# ADDENDUM No. 3

## RFP No. 24-23

### Barton/Bandemer Park Pedestrian Tunnel Project

CITY OF ANN ARBOR PRS & WASHTENAW COUNTY PRC  
 BARTON/BANDEMER PARK PEDESTRIAN TUNNEL PROJECT  
 CONSTRUCTION STAGING DETAILS

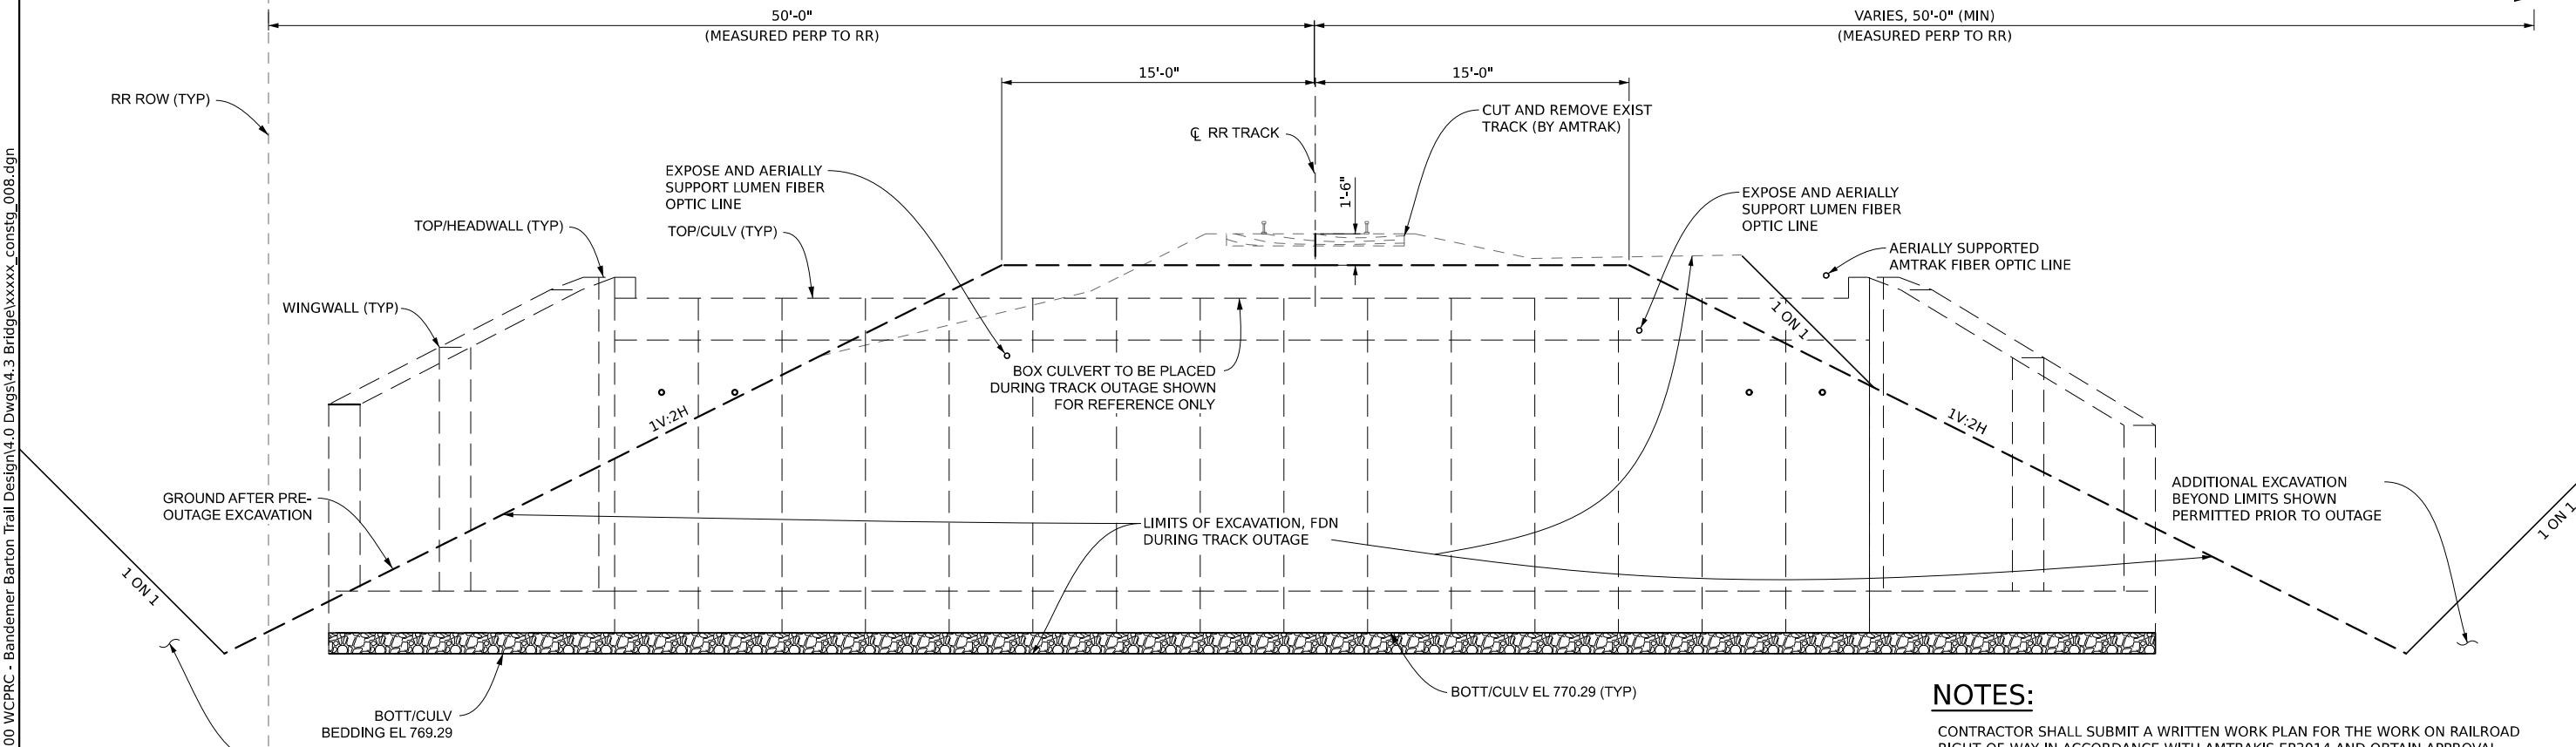
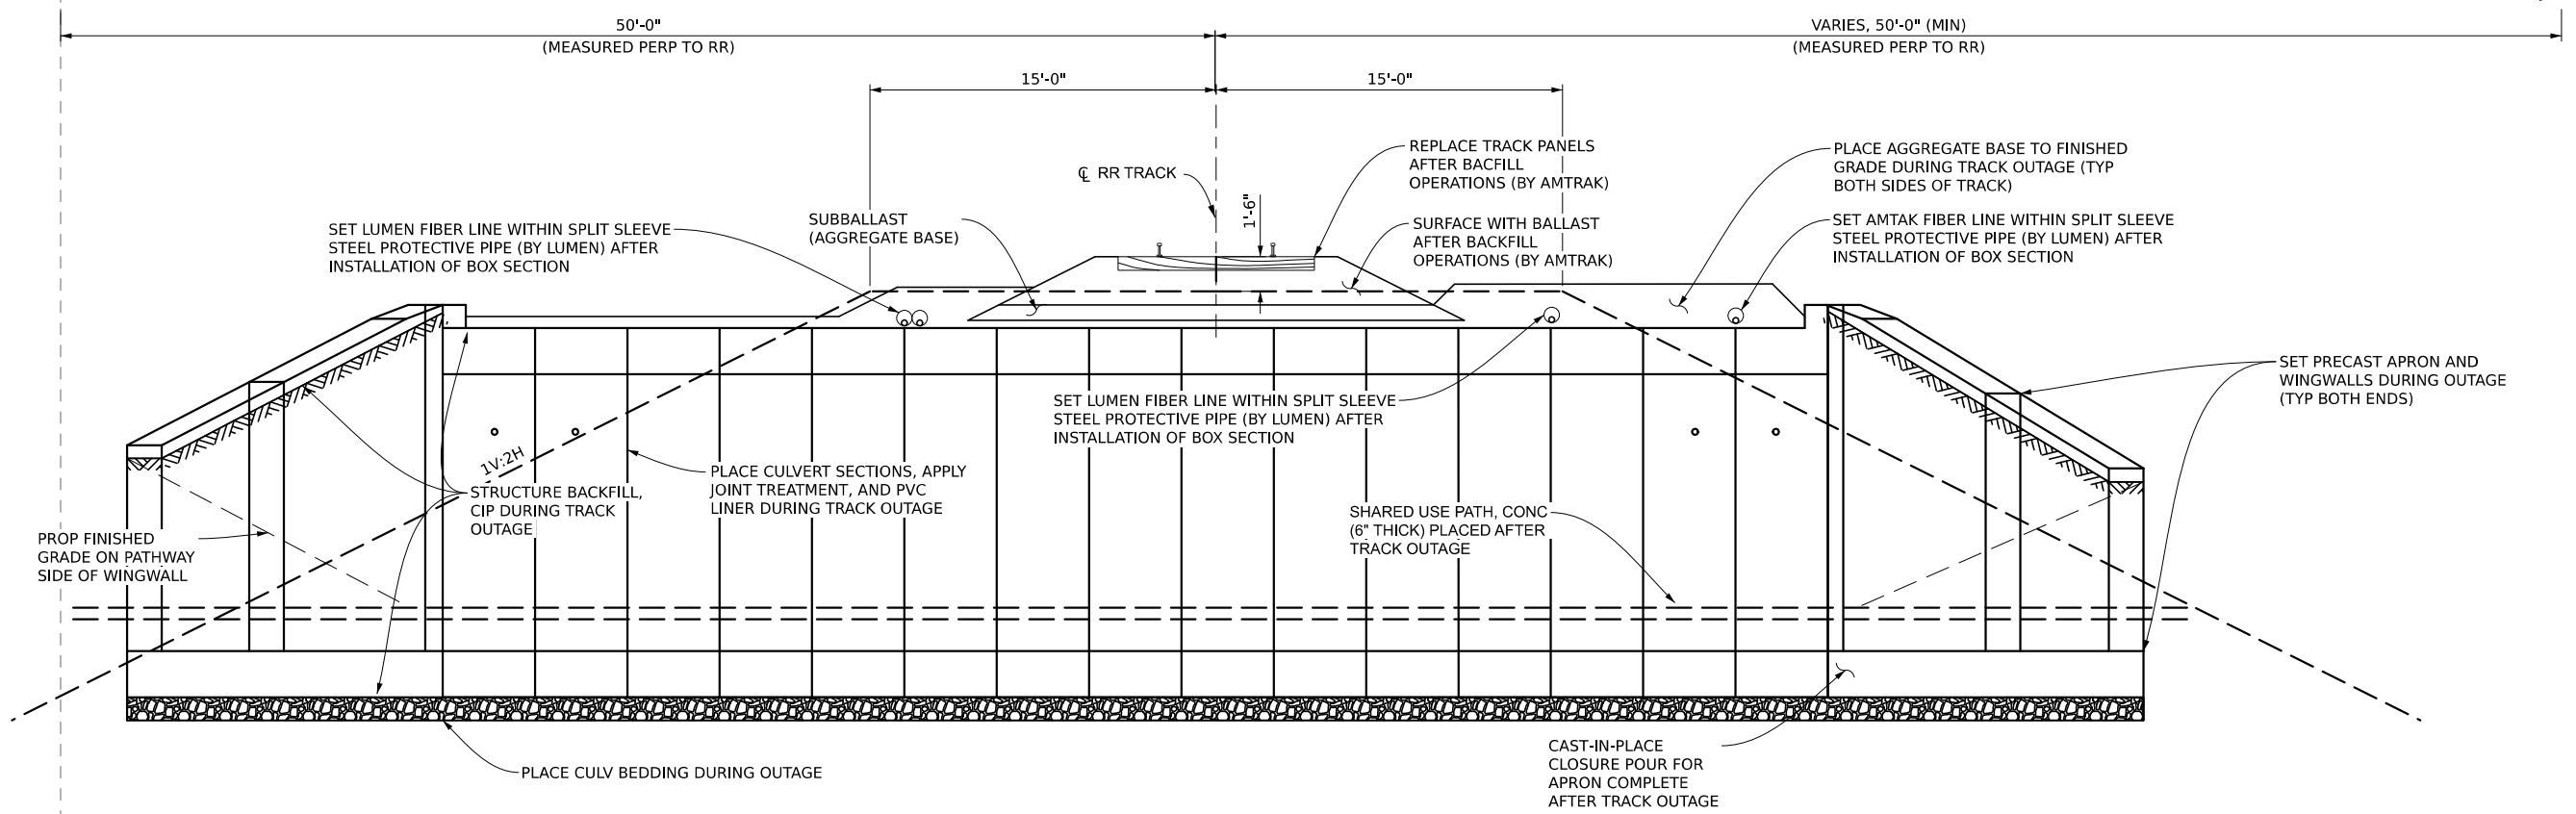
| Plans Page 31 of 80 | Replace plan sheet. Sheet revised to show staging which includes no temporary sheeting now. |

Due to the conflict noted, we are negotiating an extension of the track outage to 48-hours with Amtrak and Office of Rail. With this additional time, the updates in this Addendum 3 require that the Contractor complete the entire tunnel installation without temporary sheeting. The existing fiber optic lines will need to be supported aurally by the Contractor during the excavation and installation of the culver during the track outage.

32 of 80

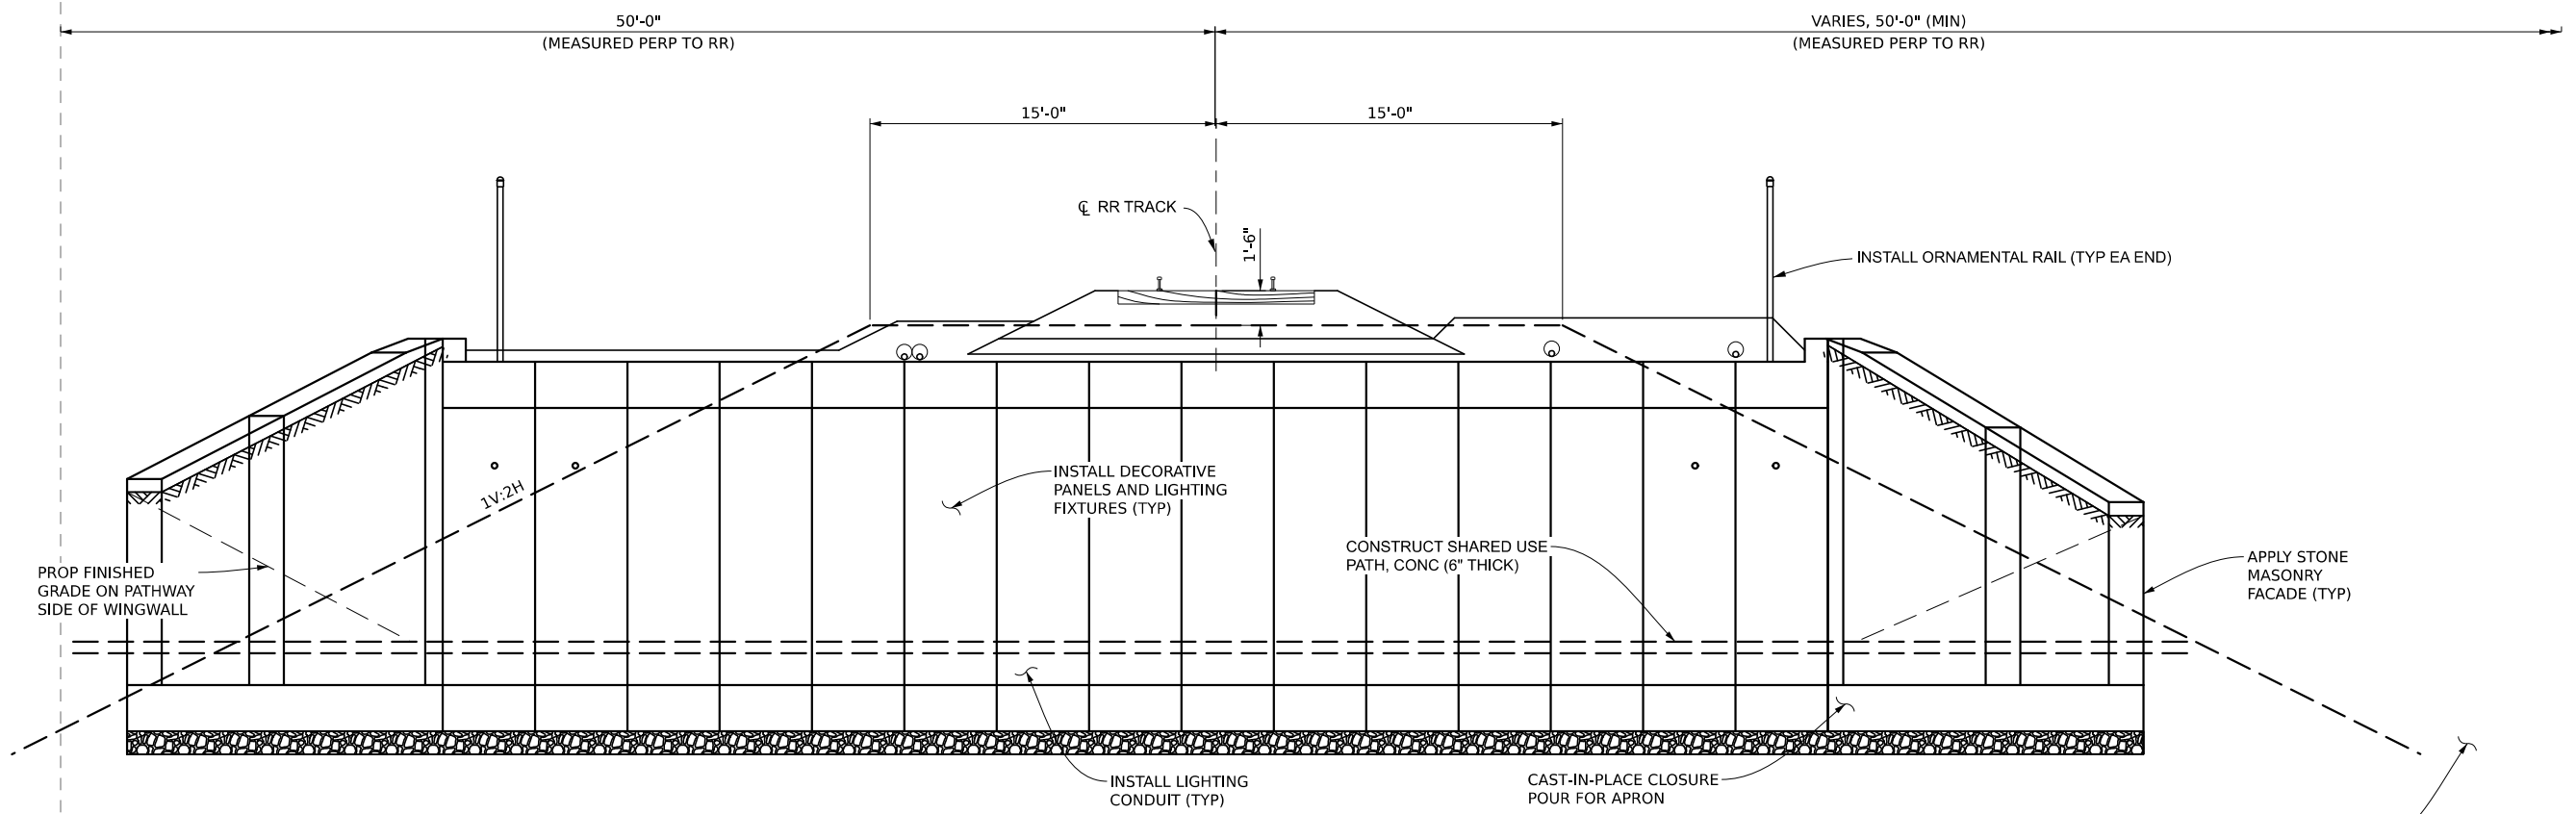
| Plans Page 32 of 80 | Replace plan sheet. Sheet revised to show staging which includes no temporary sheeting now. |
